UNITED STATES PATENT AND TRADEMARK OFFICE

Office Action Summary	Application No. 09/871,199	Applicant(s) KAIN, JAMES M.	
	Examiner Joseph F. Edell	Art Unit 3636

DETAILED ACTION

Diagram A - Annotated Figure 1A of Lemmeyer et al.

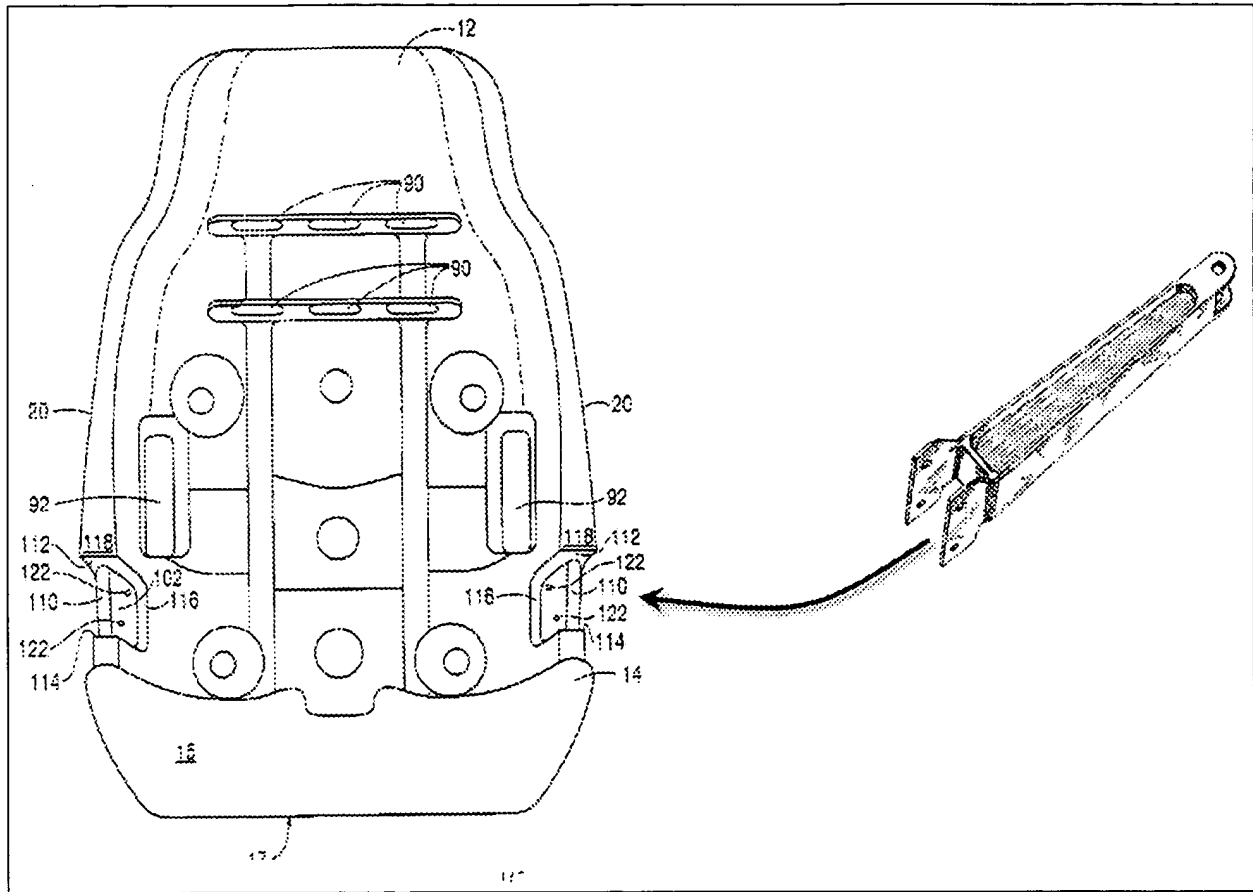
Applicant argues that rejection of claims 6-9, 11, 12, 25, and 27-29 as being unpatentable over Lemmeyer et al. in view of Marrujo because Marrujo fails to teach or suggest wings rising above the top surface of the arm. While the orientation of the wings in the Figures of Marrujo is not specified, Marrujo clearly teaches wings of a support mount extending away from the outer surfaces of the arm. Therefore, it would have been obvious to one of ordinary skill in the art at the time the invention was made to include wings on the armrest's support mount of Lemmeyer et al. Because of the horizontal orientation of the armrest of Lemmeyer et al. the modified wings of the support mount extend above and below the surfaces of the armrest. See Diagram A below to clarify the teachings of Lemmeyer et al. in view of Marrujo.

Diagram B - Annotated Figure 1A of Lemmeyer et al.

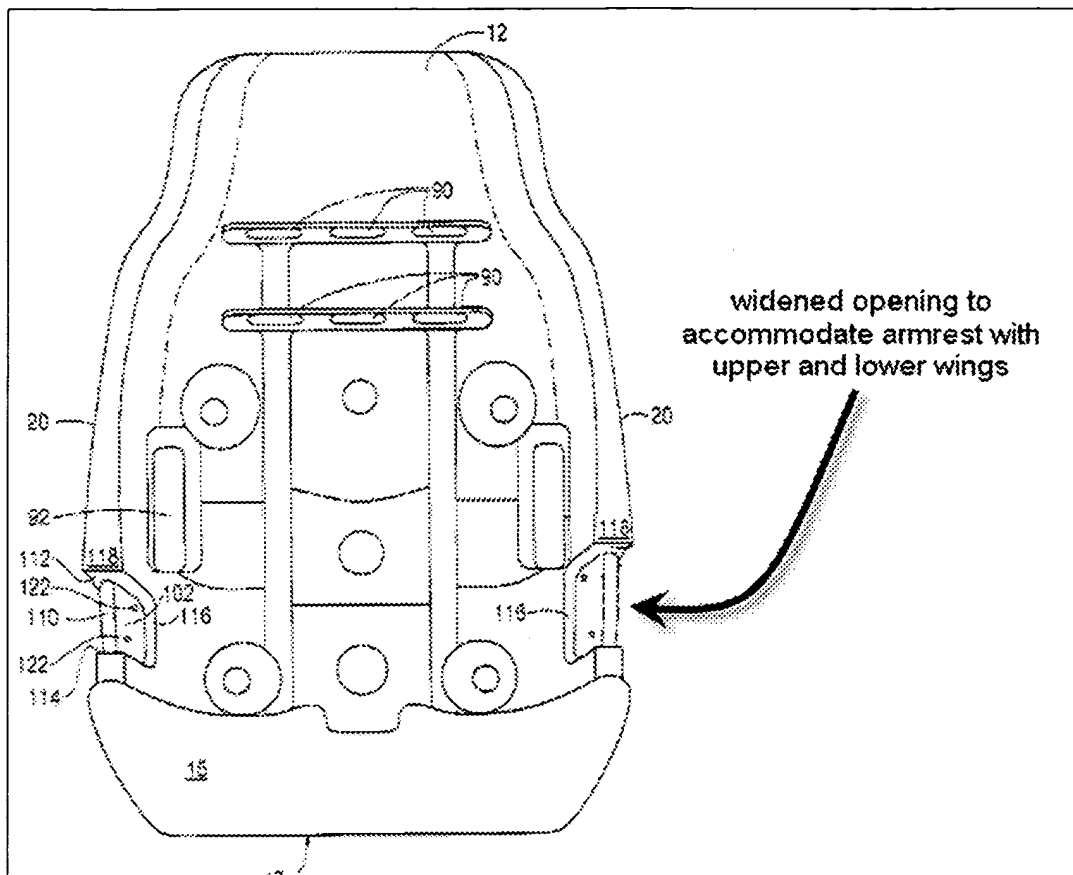
Next, Applicant argues that including wings on the armrest of Lemmeyer et al. would preclude the armrest from abutting upper and lower shelves 112,114 of the seat back ridge (shown in Fig. 1A of Lemmeyer et al.). This argument is unpersuasive for two reasons. First, it would have been obvious to one of ordinary skill in the art to widen the opening formed between the upper and lower shelves of Lemmeyer et al. to accommodate upper and lower wings extending from the armrest construction shown in Figure 1B. See Diagram B below.

Diagram C - Annotated Figure 1A of Lemmeyer et al. showing the support mount of Marrujo appended to the armrest shown in Figure 1B.

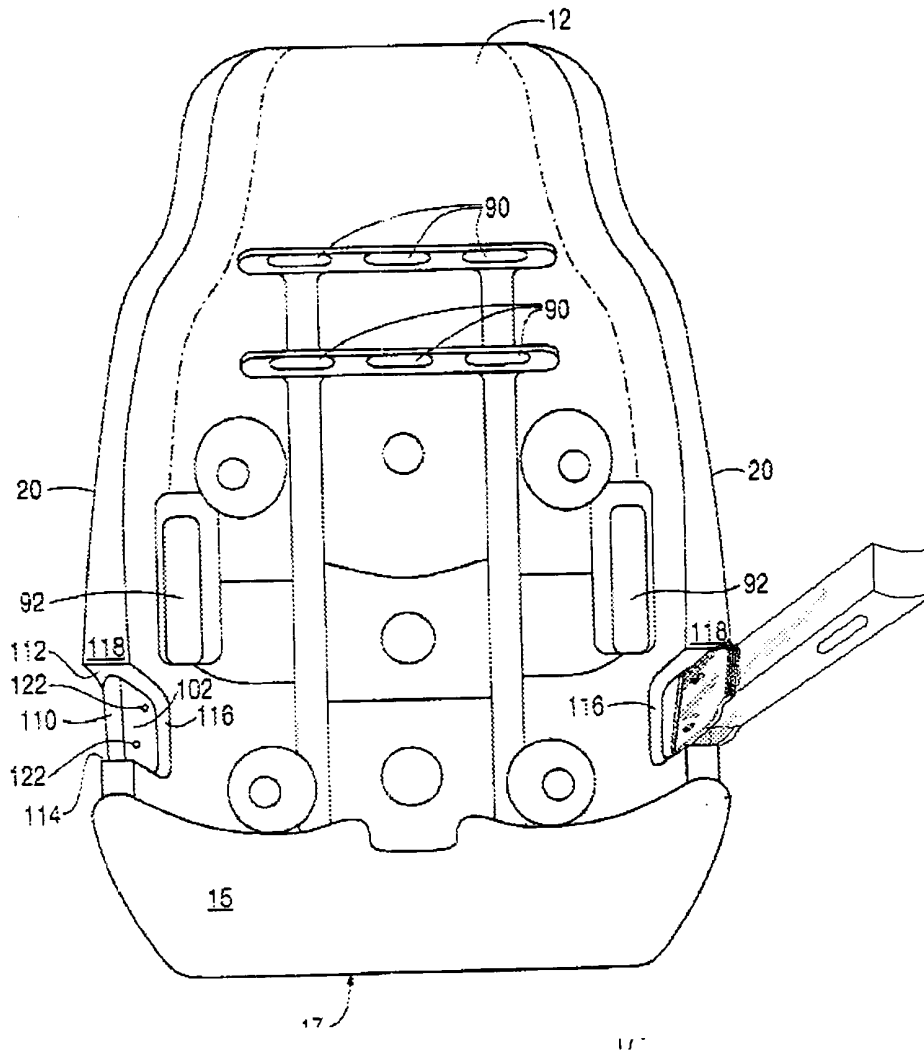
Alternatively, it would have been obvious to one of ordinary skill in the art to decrease the width of the armrest such that the support mount has upper and lower wings to extend above and below the armrest while coupling the tongue 110 between the upper and lower shelves 112,114. See Diagram C below.
